EARLY DESIGN GUIDANCE - 2ND MEETING

UW 19th Ave, LLC
4726 + 4730 19th Avenue NE Seattle, WA

EARLY DESIGN GUIDANCE - 2ND MEETING
December 12, 2018
PROJECT #3031329

OPTION C - L1 PLAN

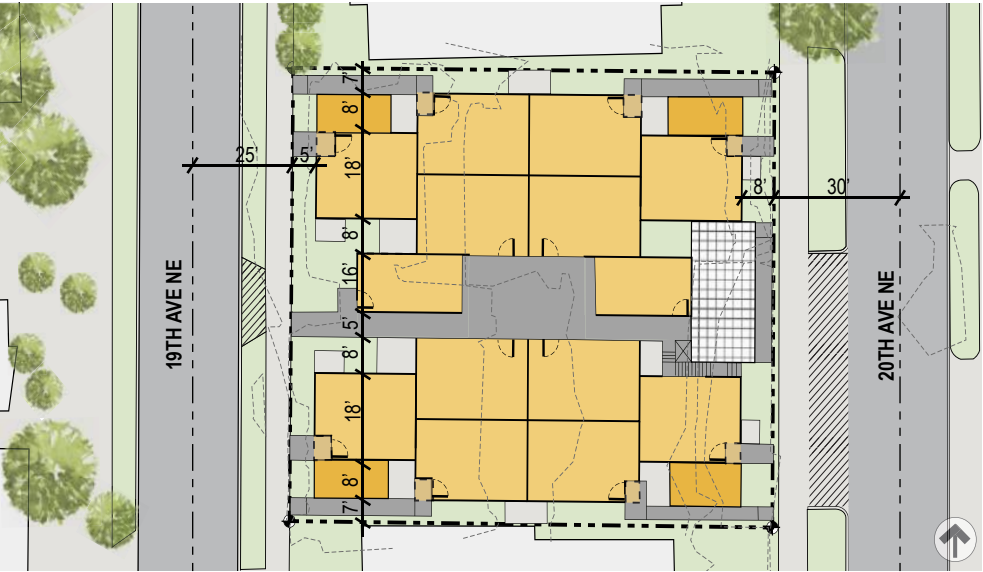
DRB COMMENTS

- MASSING: The board felt cramped and cluttered.
- PROJECT CONCEPT / DESIGN: The Board suggested to utilize cohesive, singular expression for exterior facades.
- OPEN SPACE: Common amenity spaces consist primarily of landscaped pedestrian circulation throughout the site with no usable space.
- SITE CIRCULATION: The Board suggested to have dedicated circulation separate from open space to have desirable and usable spaces.
- STREETSCAPE: The Board recommended to contribute to nearby context with a pattern of front yards and porch.

OPTION A.1

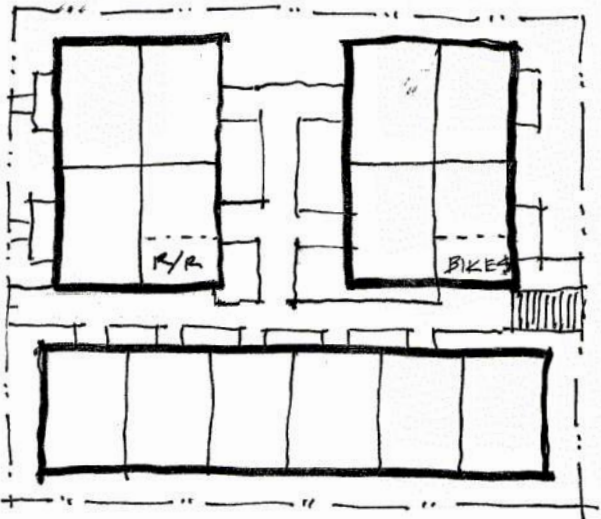
3 The Board was concerned about the usability of proposed common open space across all three schemes. The proposed common amenity spaces consist primarily of landscaped pedestrian circulation throughout the site, with no real usable space. Consolidate open space to create amenity areas that are usable and desirable, with programming that anticipates future users’ needs and encourages social interaction. (DC3)

4 The Board recommended that a quality open space concept inform the project’s overall design. (DC2-A-1)

RESPONSE: All of the revised option schemes pushed the site designs to maximize social interaction, daylighting, and opportunities for continuous open space for residents. Unit entries were placed directly off the common courtyards wherever possible. See exterior massing scheme concept sketches for studies of open space distribution.

RESPONSE: Investigation of the site plan schemes yielded a new Option D which placed interior, private resident open space as the primary site planning objective, while Option B.1 and others refined the prior placement of open space and attempted to improve upon the prior concept.

STREET ELEVATION DIAGRAM

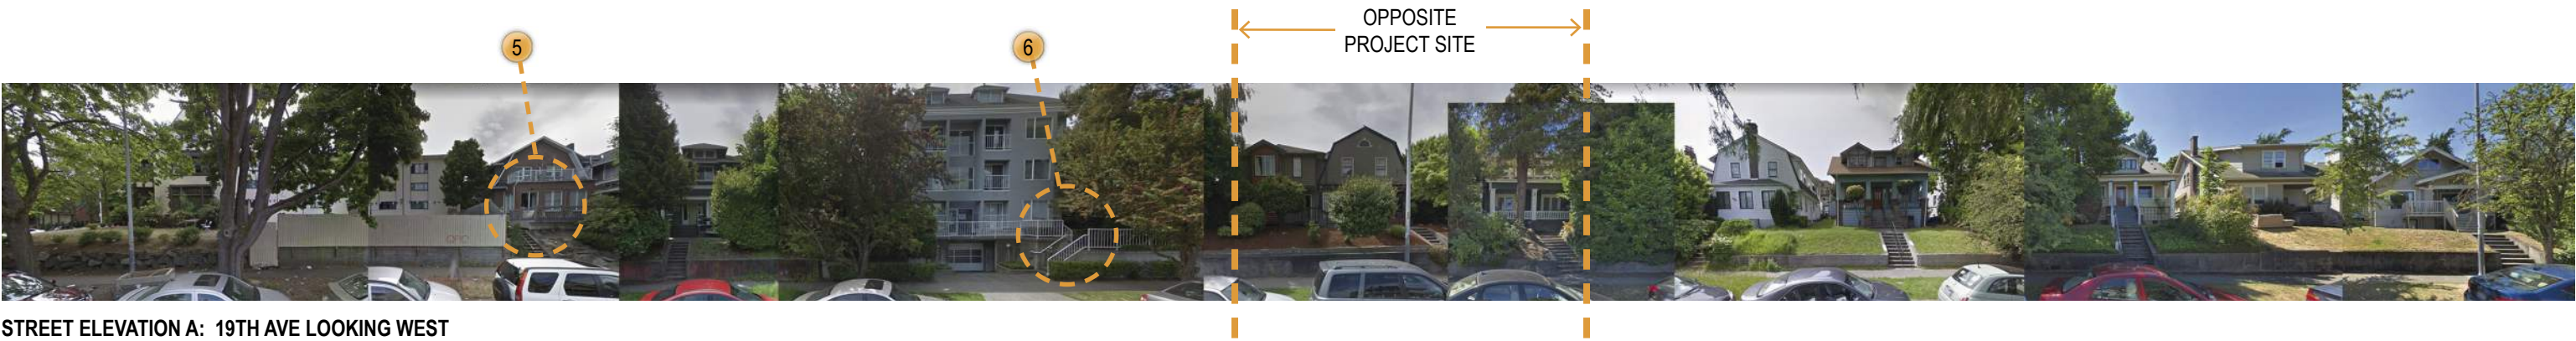
7 The Board noted the existing nearby context with a pattern of front yards and recommended that the project be designed to respect and contribute to this pattern as much as possible. (CS2-A-1, CS3-A-3, PL1-A-1)

8 Angled roof forms are prevalent in the neighborhood and are used on every building on the subject block. The Board recommended introducing angled roof forms to further connect the proposal to the existing context. (CS3-A)

RESPONSE: Front yard patterns and recessed building masses were noted as prevalent in our streetscape and frontage studies as documented in this packet. The massing for each design concept strove to incorporate the front yard / front porch pattern into the respective scheme while still responding to existing streetscape features such as neighboring datum lines, building scale, etc. See pages 18-19 & 28-29.

RESPONSE: Angled roof forms indeed are prevalent as noted in our streetscape studies documented in this packet. The massing for each design concept strove to incorporate these into their design while still responding to existing streetscape features such as neighboring datum lines, building scale, etc. See pages 18-19 & 28-29.
